**NOTICE OF DECISION TO CONSENT TO CHANGE TO PROPOSAL DURING
ASSESSMENT**

Mackay Sulphate of Potash Project
Assessment No. 2193

STATEMENT OF REASONS

Proposal: Mackay Sulphate of Potash Project

Attachment 2 – Changes to development envelope overview of proposal

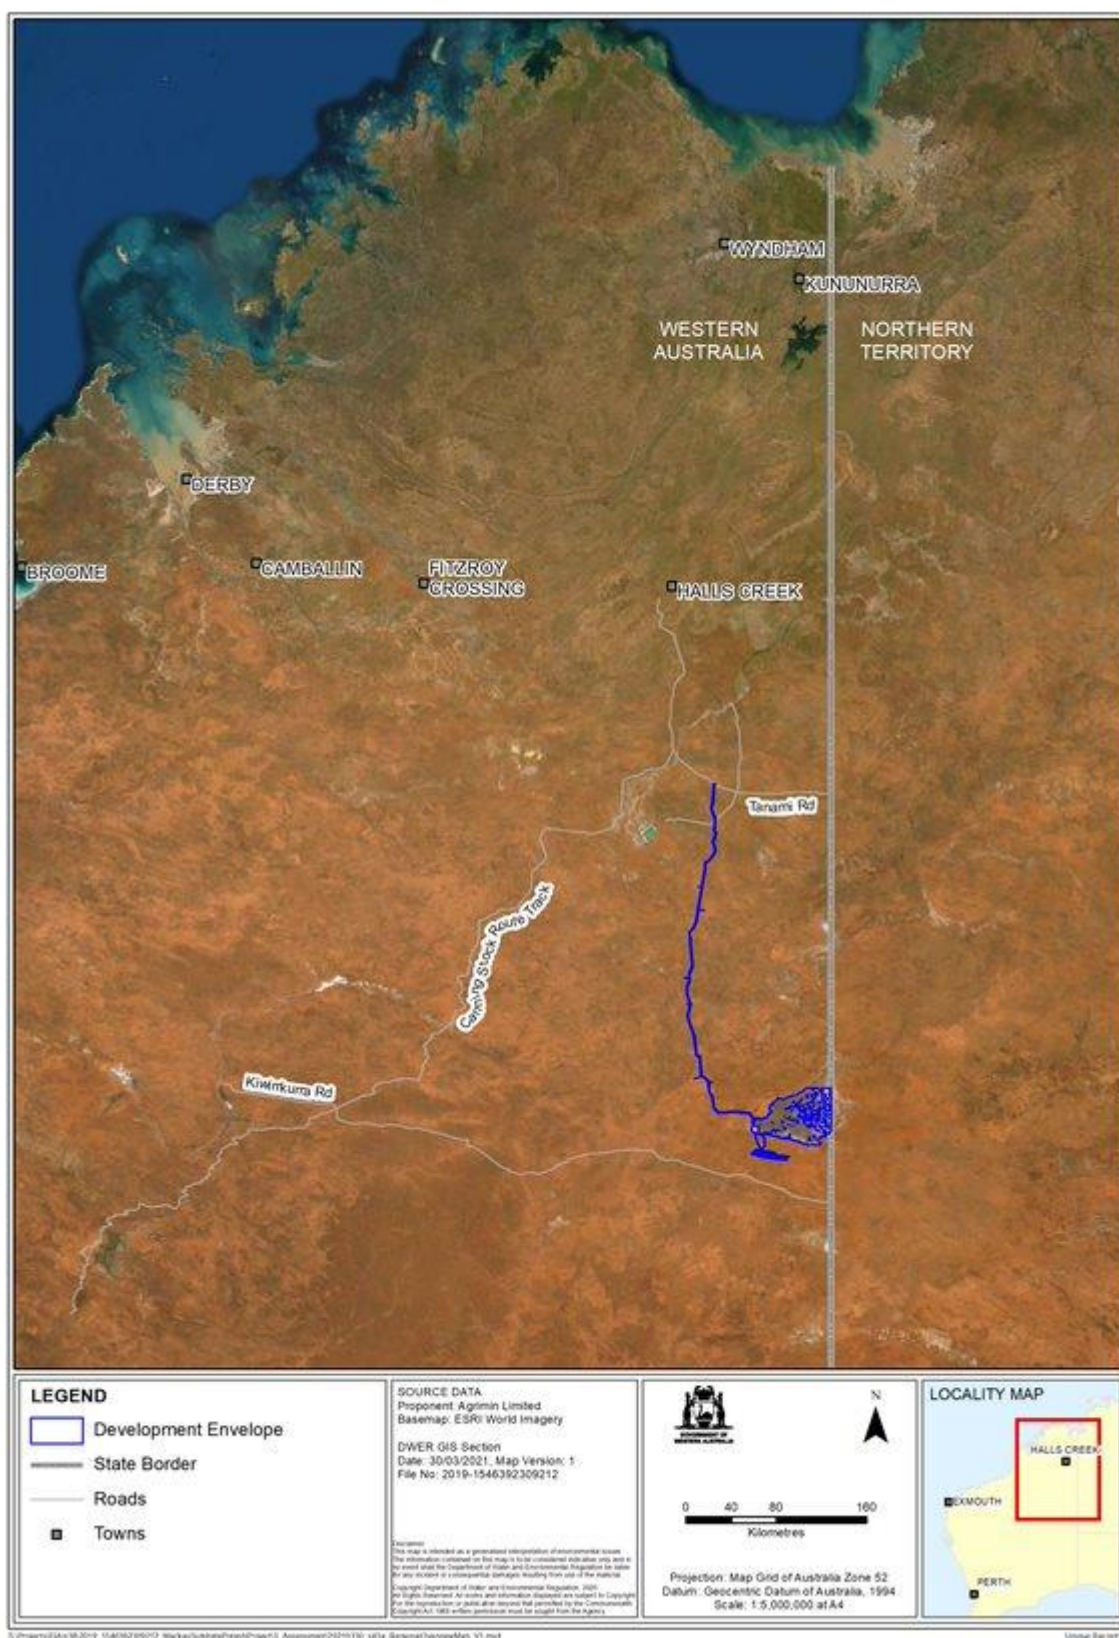
- Decrease in the On-lake Development Envelope from 218,400 ha to 217,261 ha, decrease of 1,139 ha.
- Increase in the Off-lake Development Envelope from 680 ha to 688 ha, increase of 8 ha.
- Decrease the Northern Infrastructure Development Envelope from 34,486 ha to 33,928 ha, decrease of 558 ha.
- Decrease the Southern Infrastructure Development Envelope from 11,829 ha to 11,799 ha, decrease of 30 ha.

See Figure 1 and 2 that depicts the changes to the development envelopes.

Figure 2 – Changes to development envelope overview of proposal

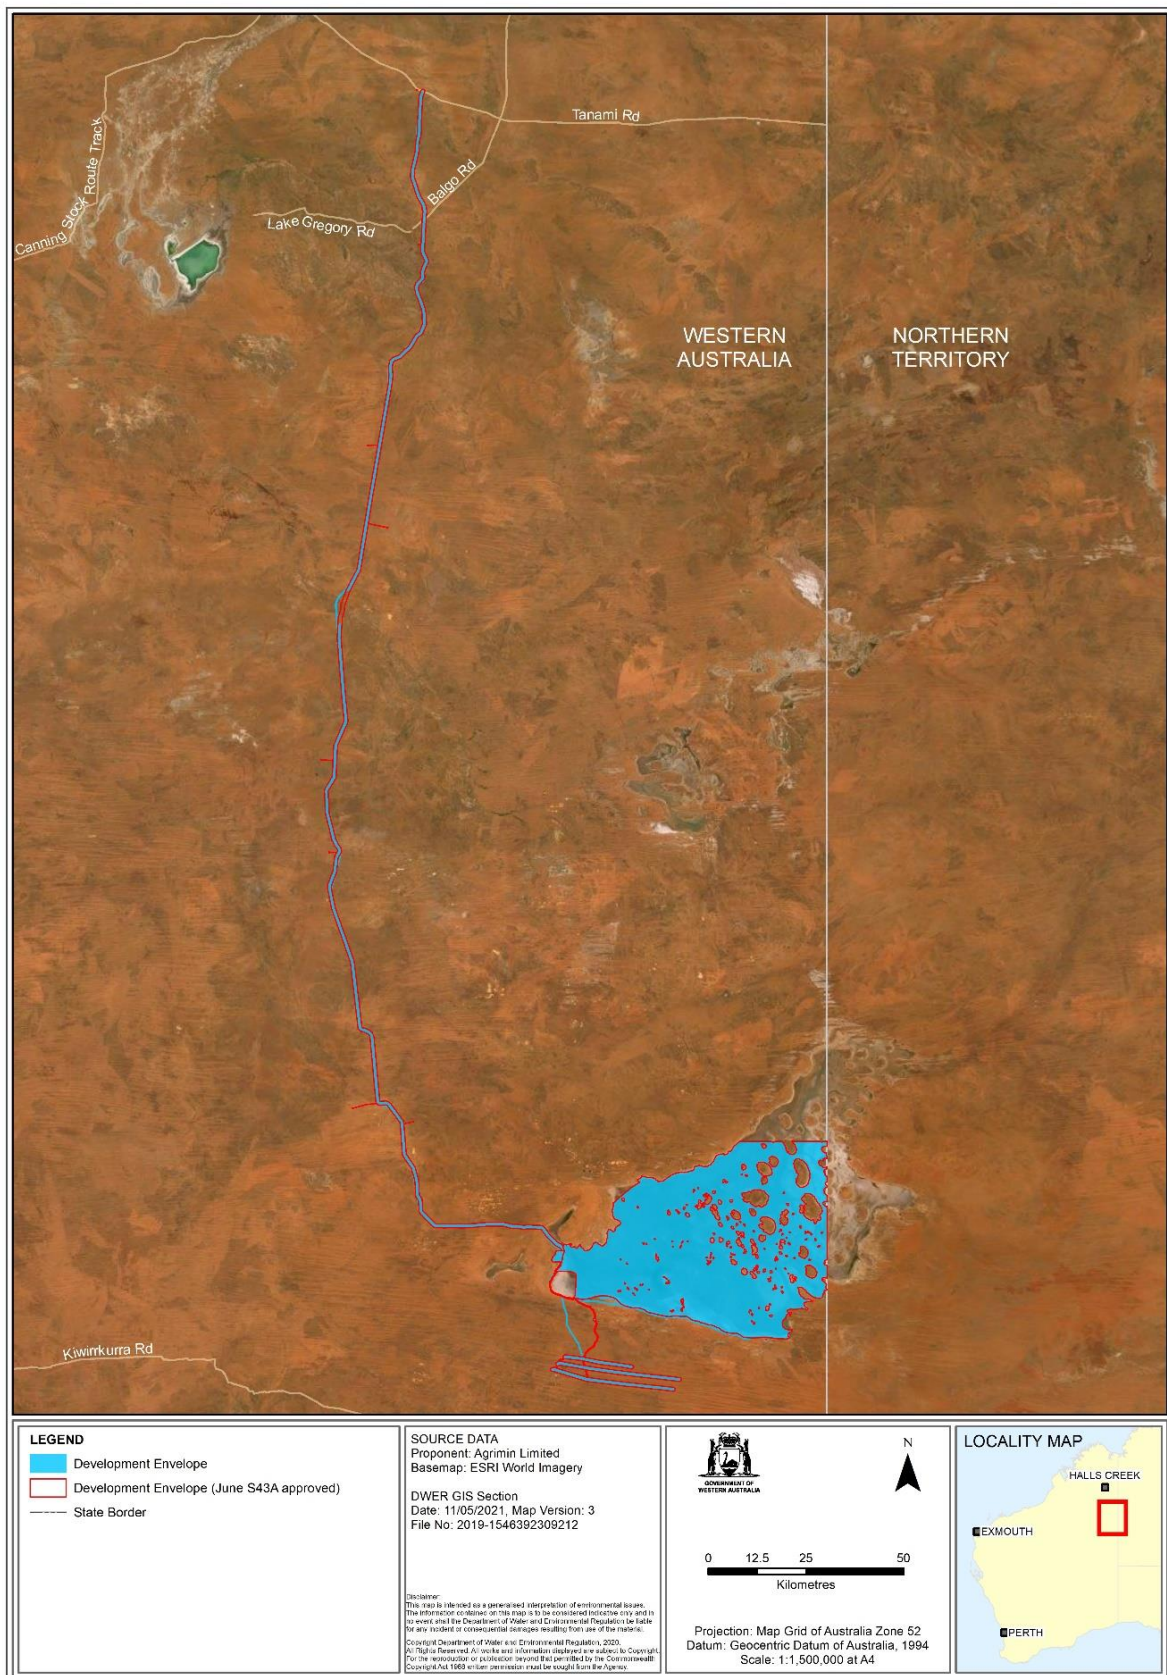
- Decrease in the On-lake Development Envelope from 218,400 ha to 217,261 ha, decrease of 1,139 ha.
- Increase in the Off-lake Development Envelope from 680 ha to 688 ha, increase of 8 ha.
- Decrease the Northern Infrastructure Development Envelope from 34,486 ha to 33,928 ha, decrease of 558 ha.
- Decrease the Southern Infrastructure Development Envelope from 11,829 ha to 11,799 ha, decrease of 30 ha.

- Extent (intensity, duration, magnitude and geographic footprint) of the likely impacts
 - The changes will result in a reduction in total area of the development envelopes from 265,395 ha to 263,676 ha, a decrease of 1,719 ha (0.6%), and no change in total clearing of native vegetation of no more than 16,500 ha across all four development envelopes.

Figure 3 – Changes to the on-lake development envelope

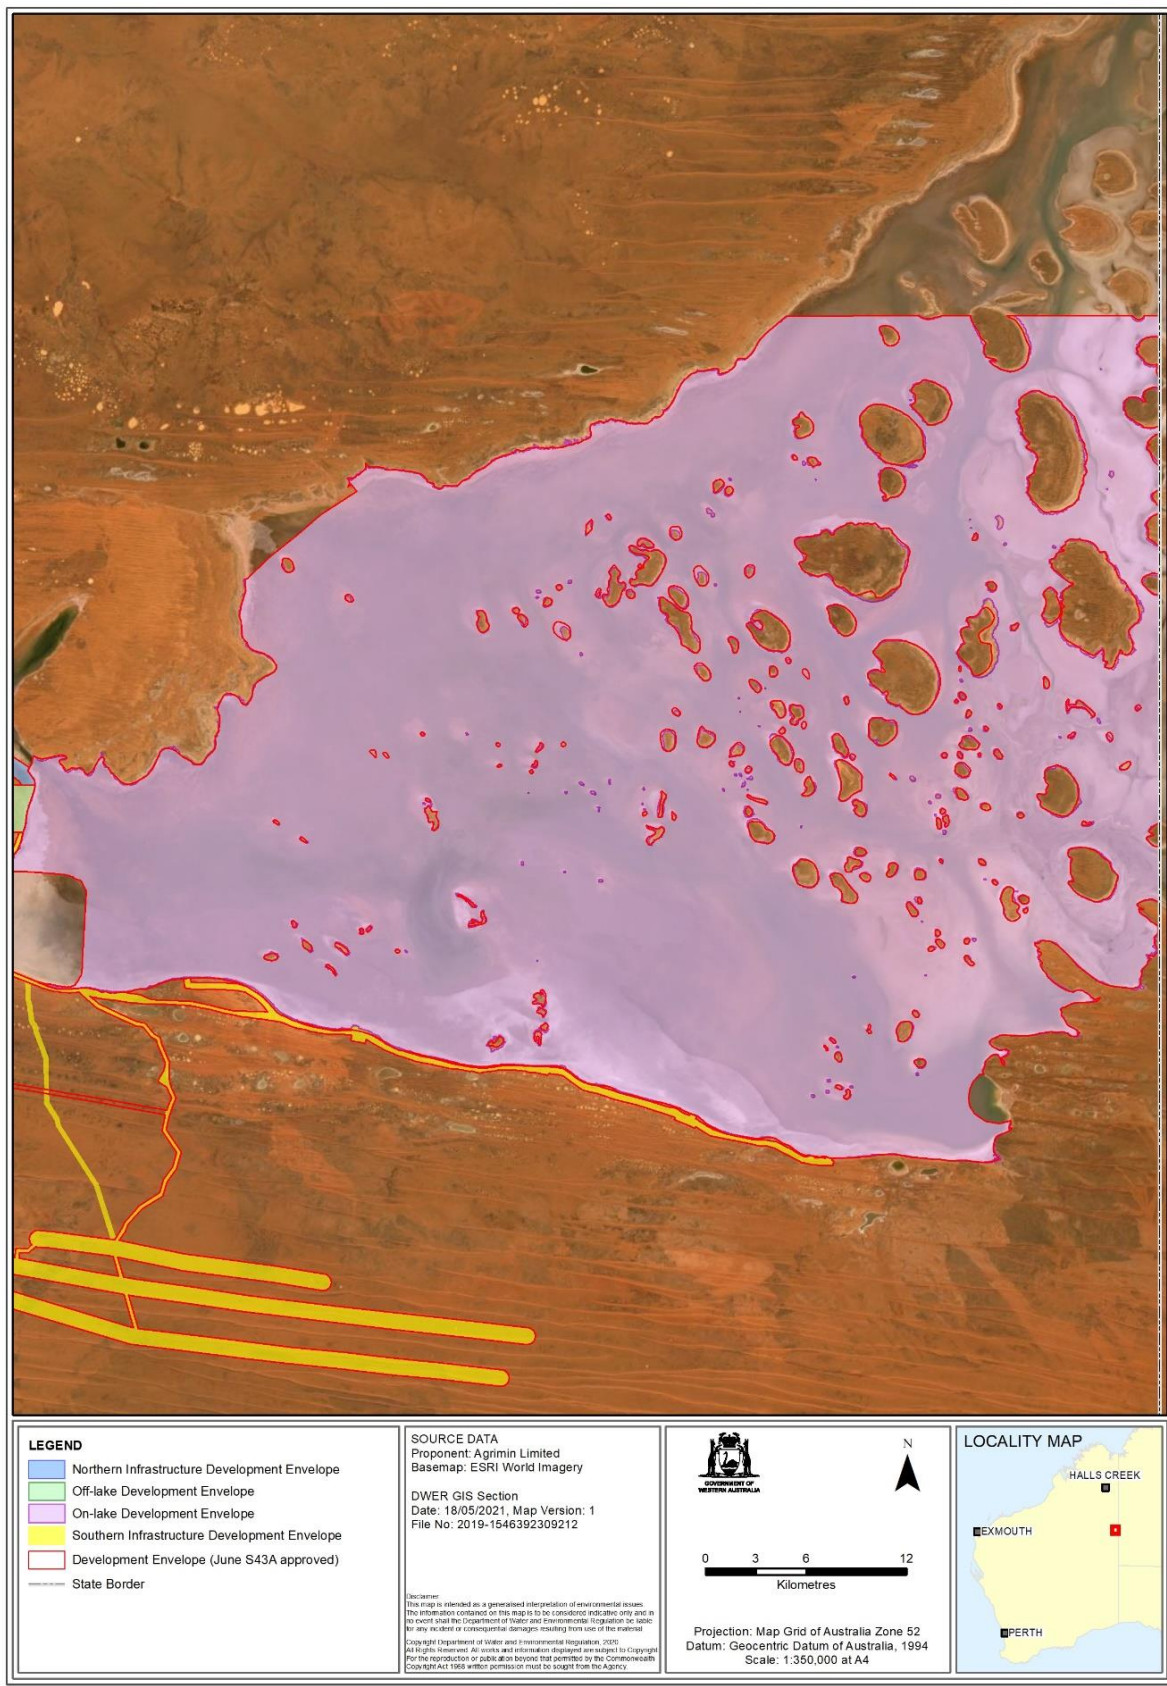
Since the approval of the previous Section 43A on the 12 June 2020, the proponent has undertaken mapping work that has refined the On-Lake Development Envelope, with particular focus on the lake islands and their margins. Where the spatial files had previously outlined arbitrary boundaries around the lake edge and islands, further fine-scale mapping work has been undertaken for the purpose of enhancing the lake riparian zone boundary interface, to depict exclusion zones more accurately. In undertaking this work, the On-Lake Development Envelope has been reduced by

1,139 ha, so that its extent is now proposed to be 217,261 ha. There is no proposed change to the amount of disturbance within this envelope.

Figure 5 – Changes to the northern infrastructure development envelope

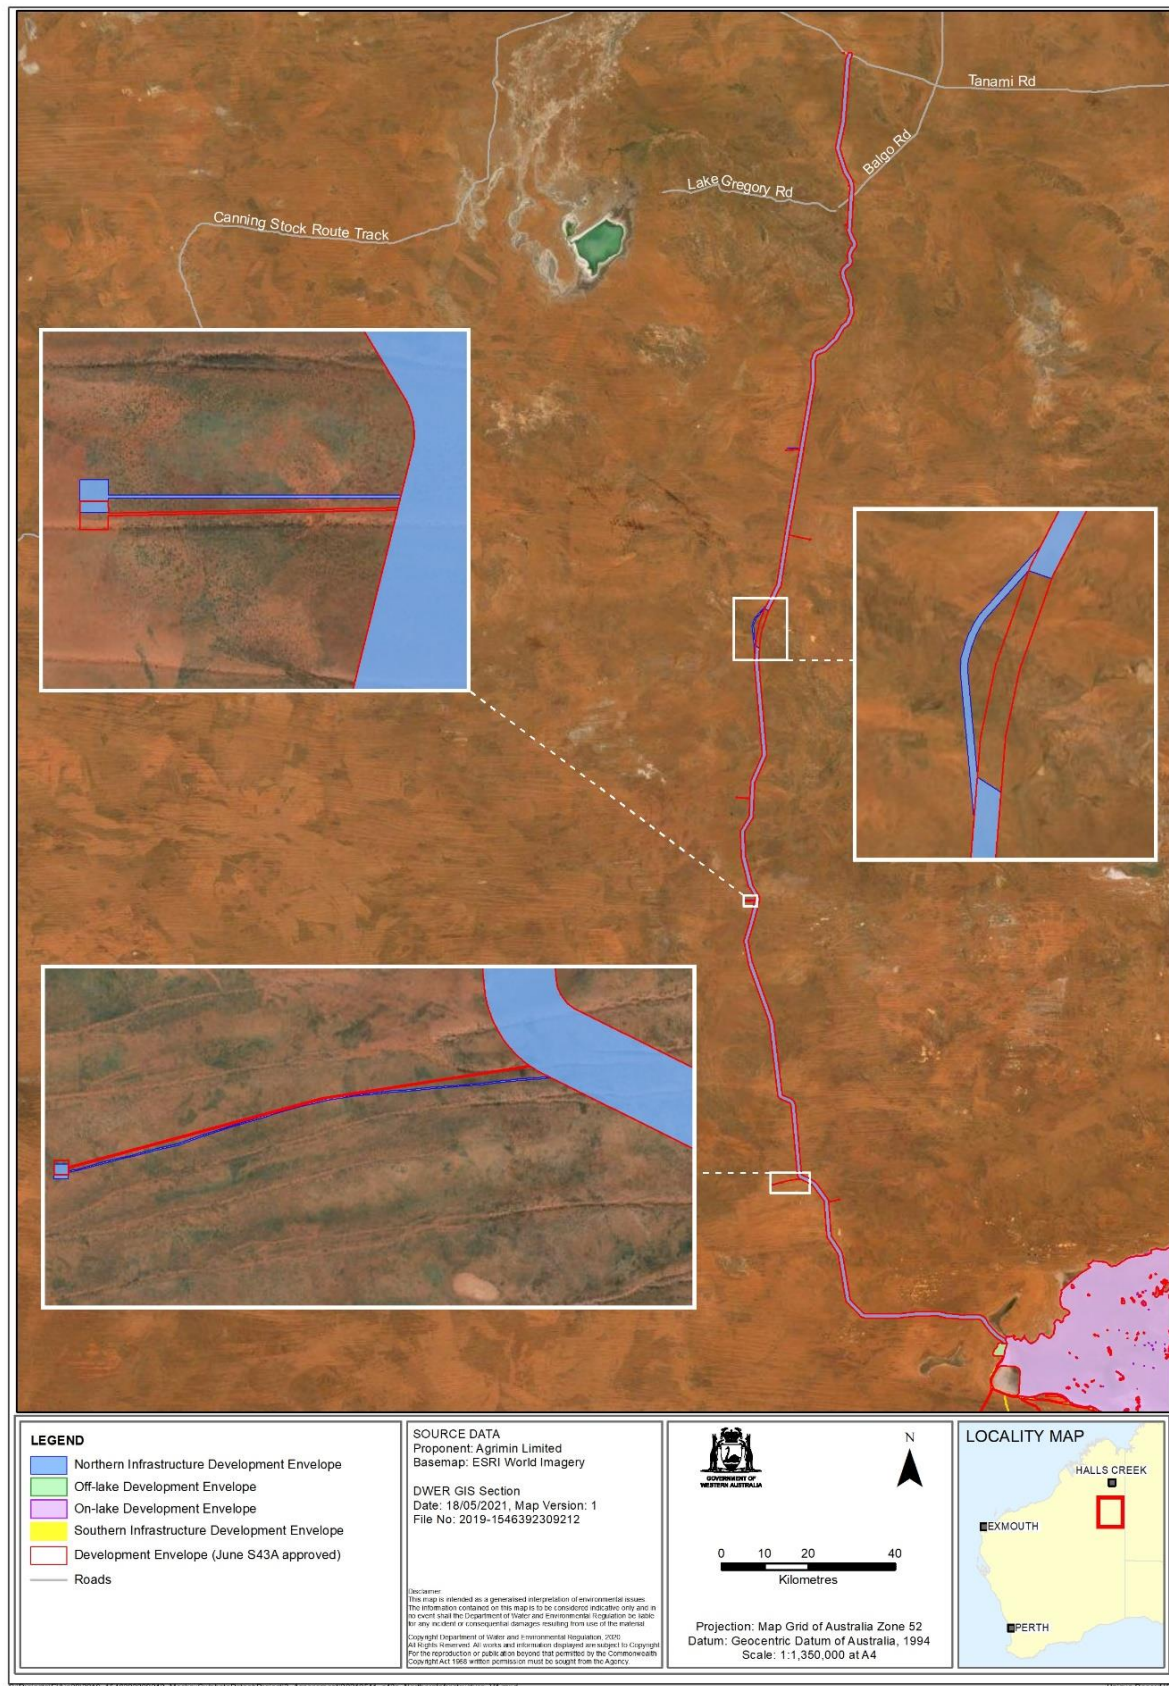
Re-alignment of the Northern Infrastructure Development Envelope including:

- A deviation from the current proposed alignment with a reduced corridor width, avoiding a population of Great desert skink (Listed nationally as vulnerable).
- Refining the location of access tracks leading from the haul road to borrow pits to reduce footprint and follow favourable topography of the landscape.
- Decrease the size of the NIDE from 34,486 to 33,928 ha.
